May 5, 2014
BOARD OF COUNTY COMMISSIONERS
ORANGE COUNTY, FLORIDA
Addendum No. 6, IFB Y14-782-RM

**ORANGE COUNTY ROADS AND DRAINAGE DIVISION - THREE POINTS
MAINTENANCE FACILITY**

GARAGE / WORKSHOP PLAN - LIGHTING

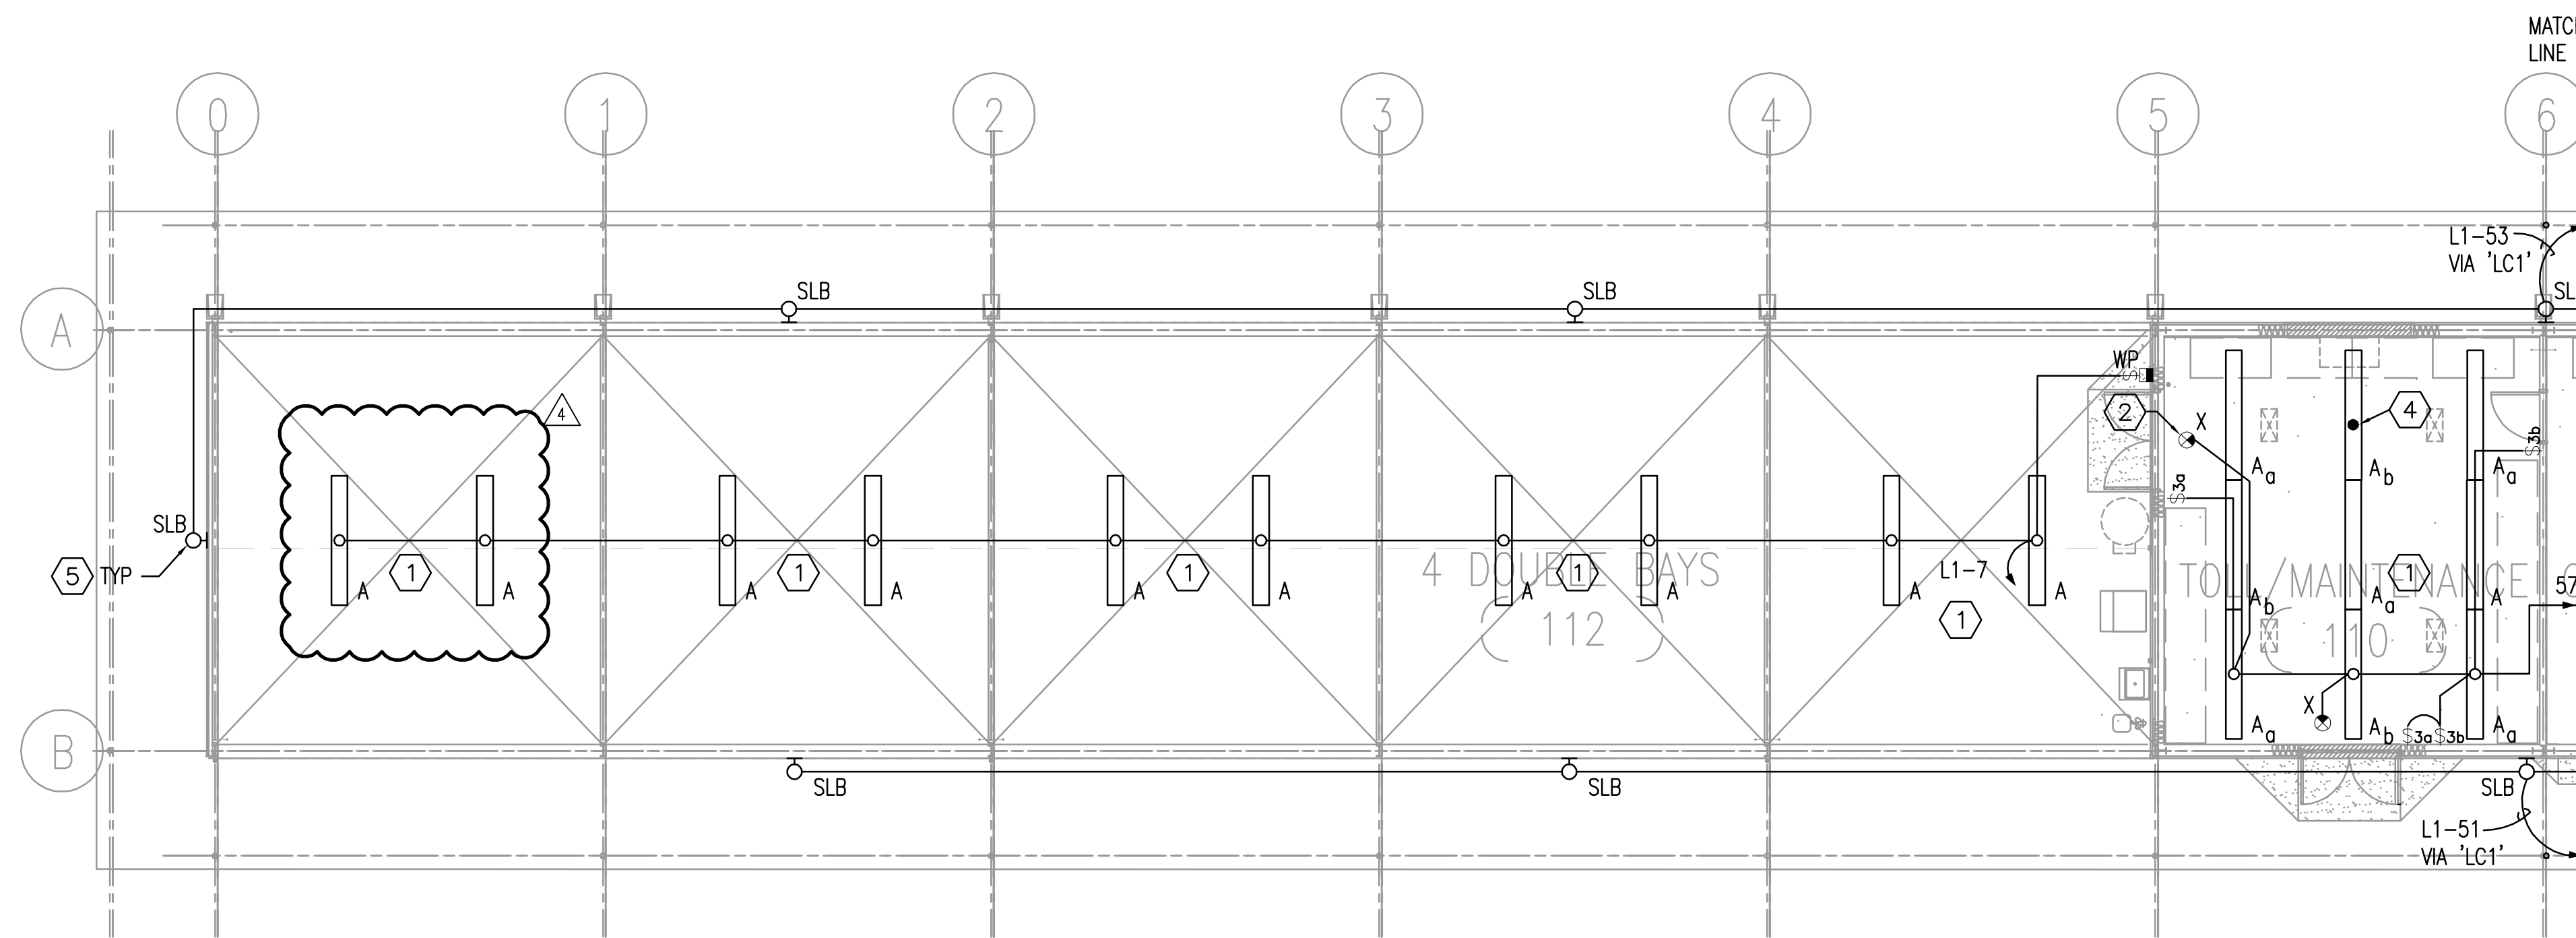
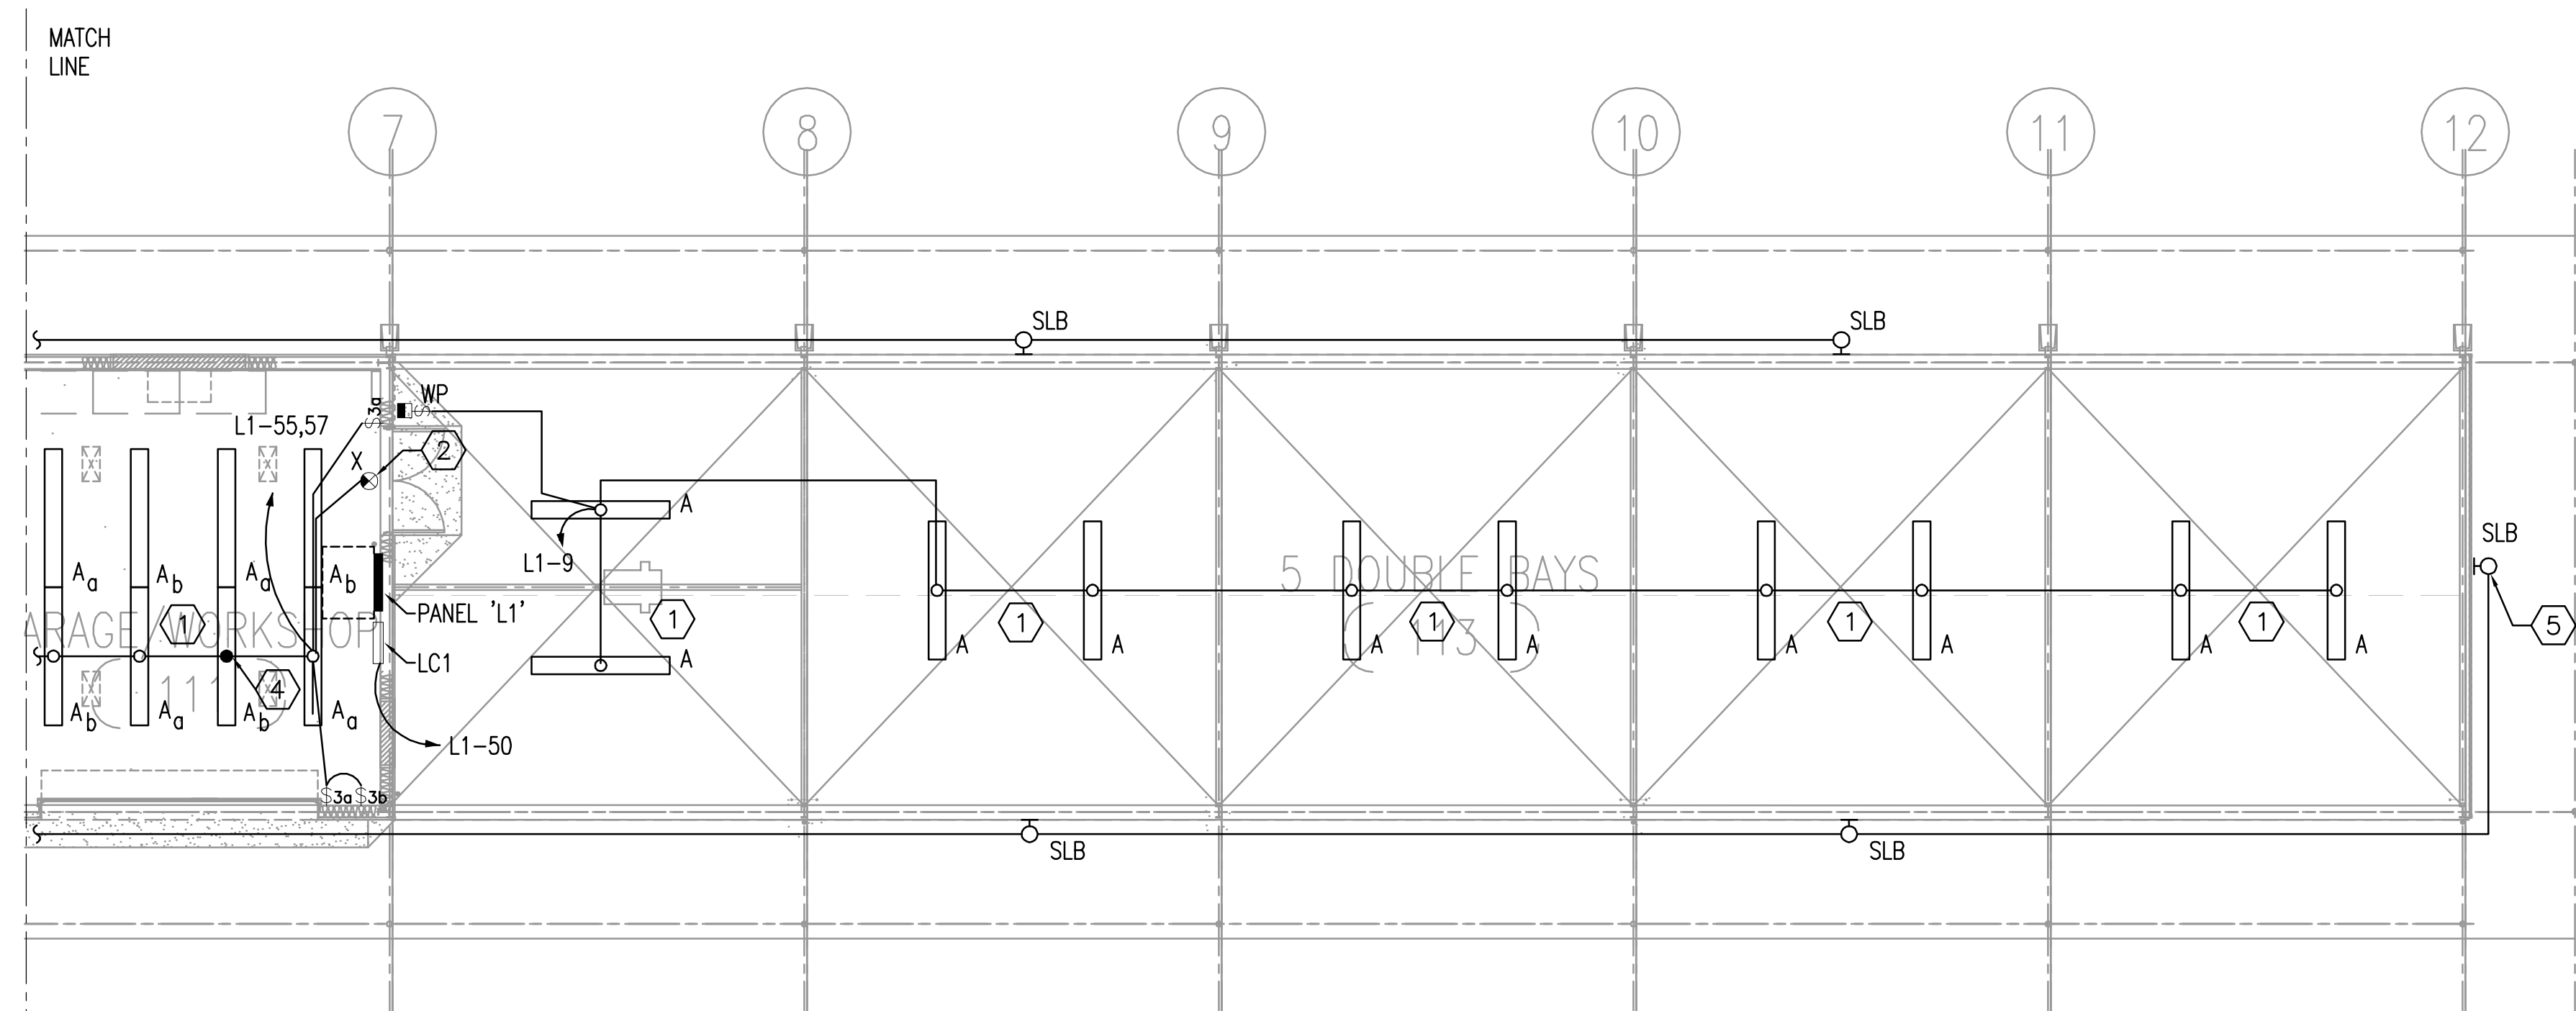
1. The following drawings, have been revised:
 - a. Sheet E4.3 Dated 04-29-2014. ADD: Lights to the end bay (grid A-B/0-1) of the garage workshop building (see attached).
